Modification Report No.5

Tweed Valley Hospital SSD-10353: Changes to Multi-deck Carpark

Prepared for: NSW Health Infrastructure
© GeoLINK, 2022

Figure 3.1 Approved south elevation of the multi-deck carpark.

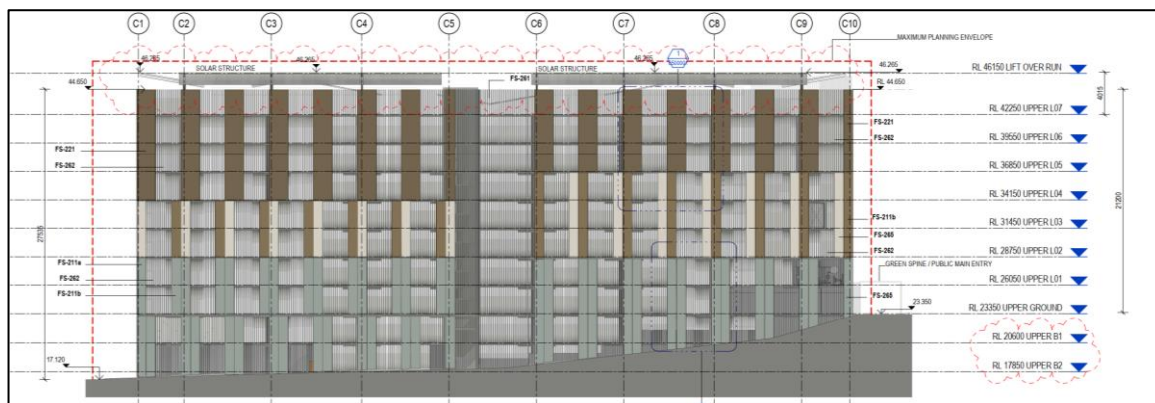
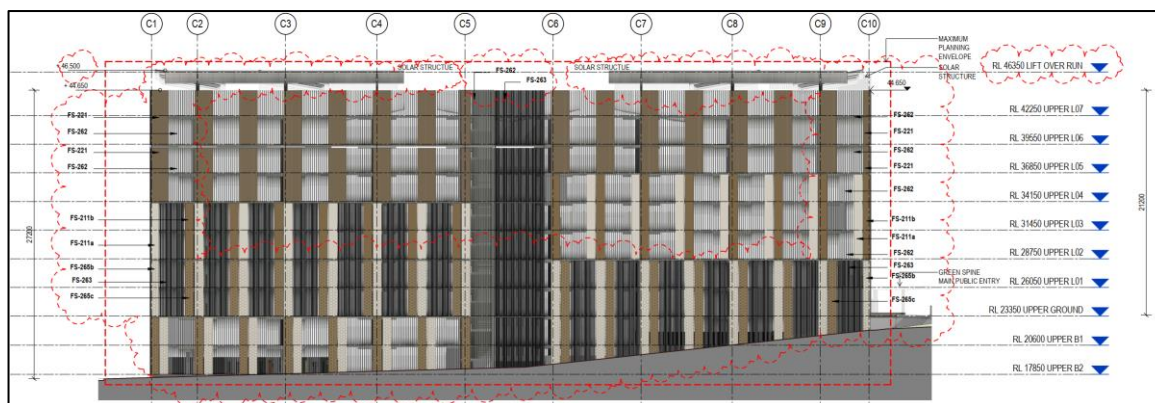
To achieve the required unobstructed percentage as per the Fire Engineering Brief Consultation Questionnaire (FEBQ) the façade panels need to have perforations of 73% Open on the Ground Floor and Level 1, and 55% for Levels 2 to 5 respectively. The perforation hole types have also been revised to achieve this perforation level and maintain structural integrity.

Figure 3.1 and **Figure 3.2** provide a sample comparison of the approved and modified southern elevations of the multi-deck carpark, demonstrating a strong similarity.

Figure 3.2 Modified south elevation of the multi-deck carpark.
